HARDWARE PATCH for Zemmix Neo, SX-1, SM-X and related machines (update 2020.04.06)

2020.08.19 Hardware Patch for OCM machines “aka BUSDIR_n patch”

2020.10.16 Hardware patch for Zemmix Neo BR machines (aka +5V line stability fix)

2022.06.02 Hardware Patch for SM-X, SX-2 and related machines (aka PS/2 keyboard compatibility fix) [Revision 2]

THE FIX:

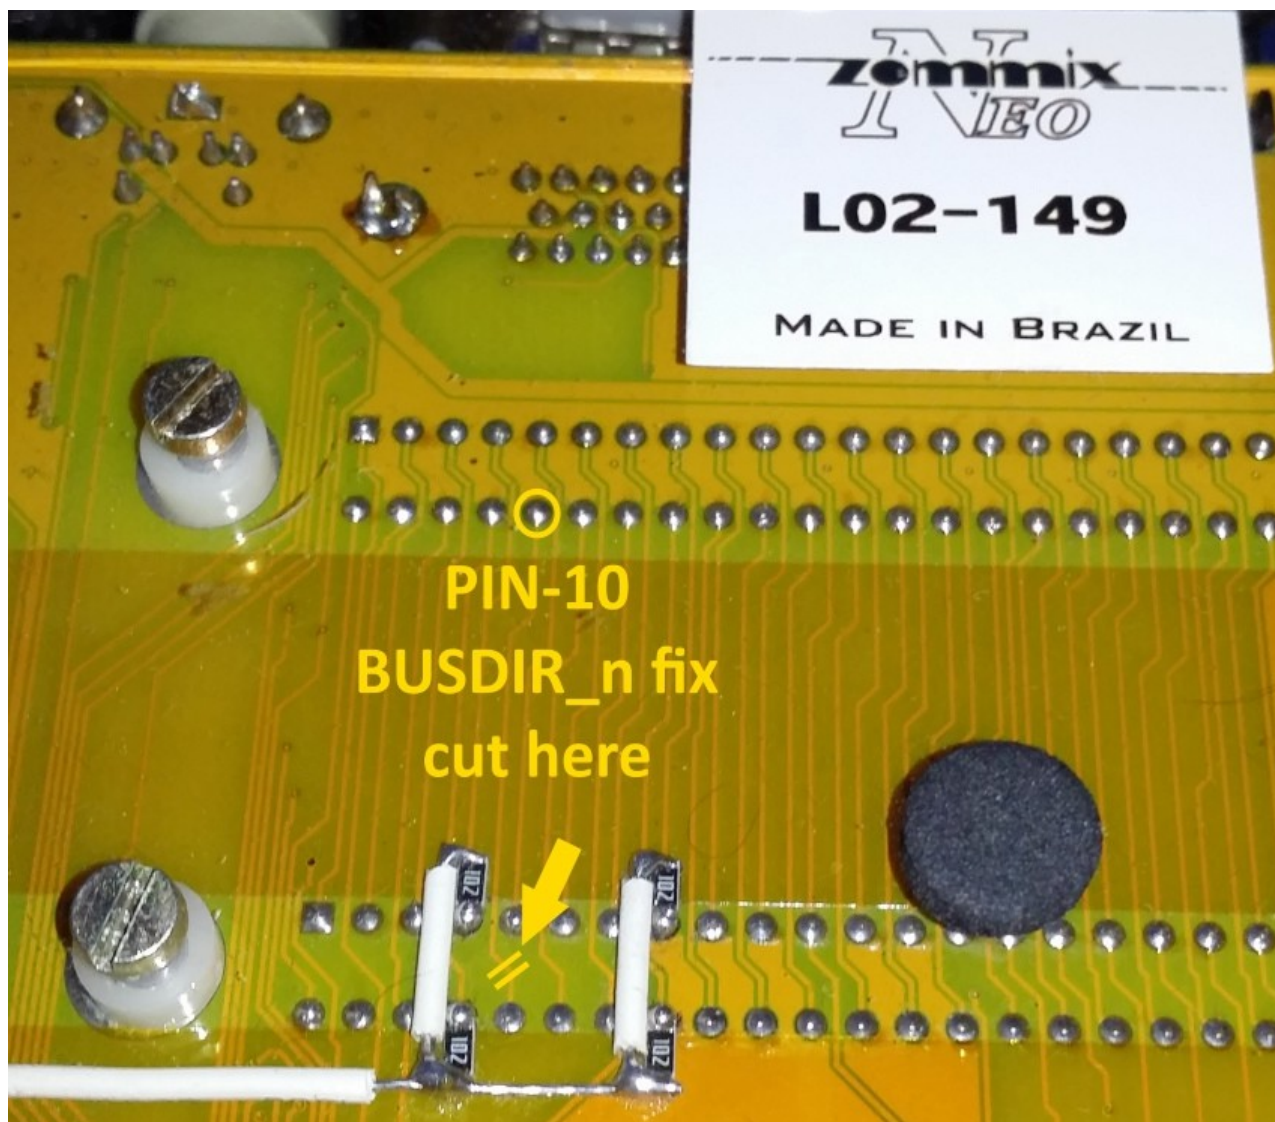
- In OCM machines we have a short circuit between pin-10 (BUSDIR_n) of the two external slots that continues towards the FPGA. This type of connection confuses some cartridges.
- While the Panasonic FS-A1ST and Canon V-20 service manuals confirmed that the BUSDIR signal is not used.

- Pin-10 (BUSDIR_n) of the external slots must be isolated.

- Method 1 - Cut the track that connects pin-10 of Slot-1 and Slot-2 leaving unchanged the connection to the FPGA already internally isolated by the firmware.
- Method 2 - Desolder pin-10 of slot-2 from the PCB and insulate it with the sheath of an electric wire and a drop of hot glue.
- Method 3 - Place non conducting tape over pin 10 of those cartridges that are not working properly, such as MoonSound and Darky.

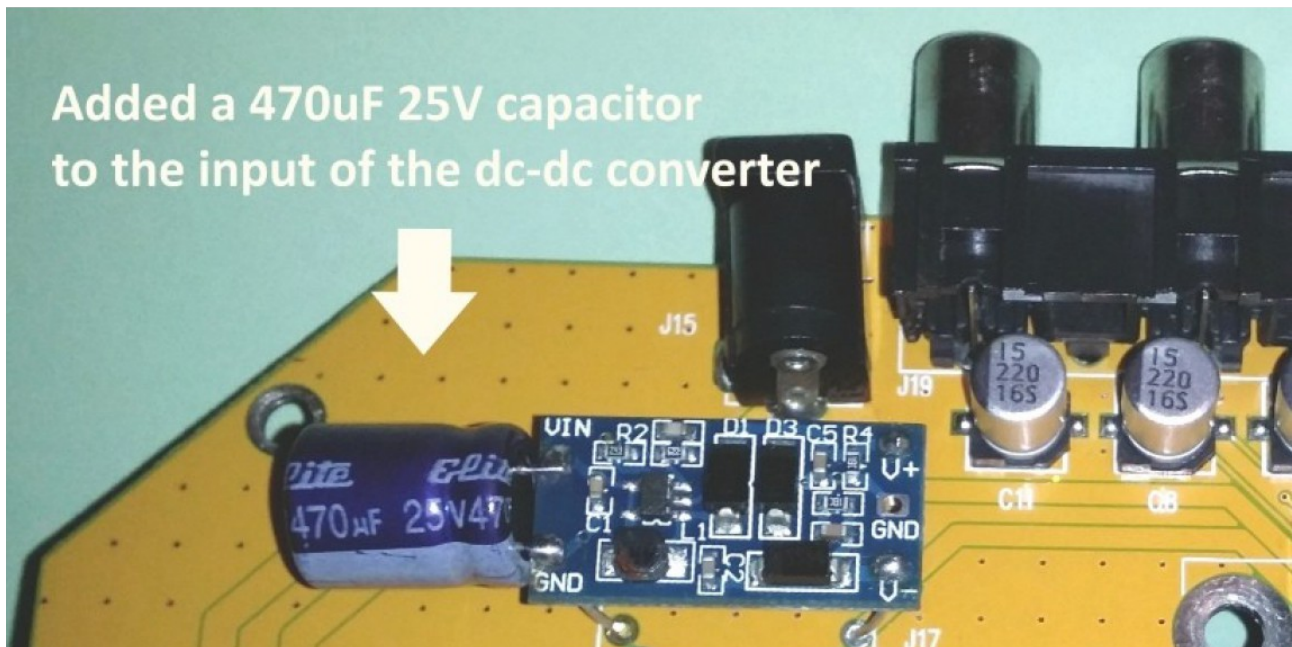
Based on the wiring diagram of the original 1chipMSX machine, I have implemented this new hardware patch for Zemmix Neo Brazilian which allows to stabilize the +5V input line. This patch can for example remove some annoying video interference on the output of GFX9000 and other similar cartridges. Please be informed that the problem is currently only present on Zemmix Neo Brazilian and not with Zemmix Neo Korean, but this fix can still be used if your hardware is unstable.

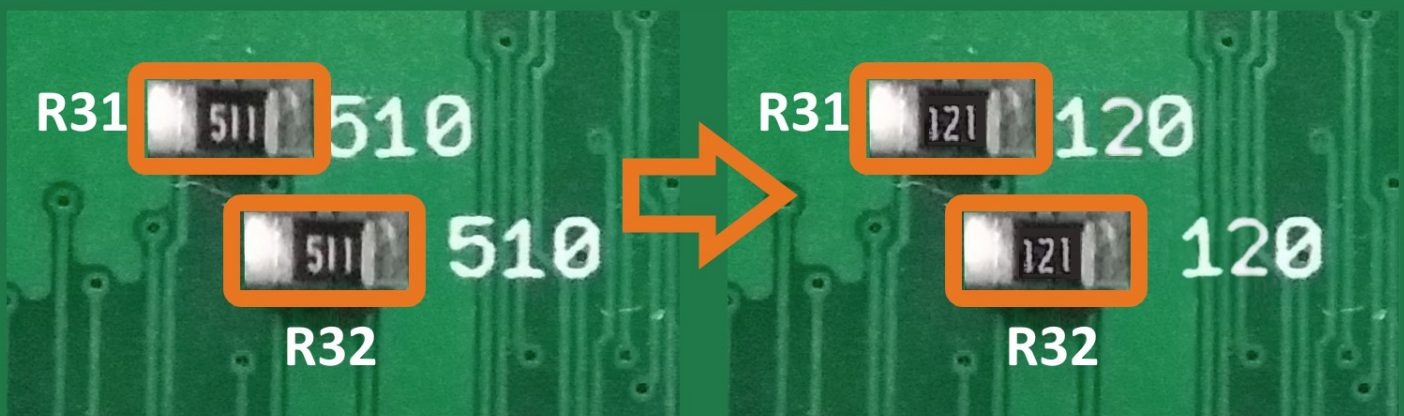
This is an optional fix. If your keyboard is NOT working properly you can apply this hardware patch or purchase another keyboard.

**How to do it: replace the resistors
R31 and R32 with a value between 120 Ω and 390 Ω .
A value of 120 Ω is recommended to ensure maximum compatibility.**
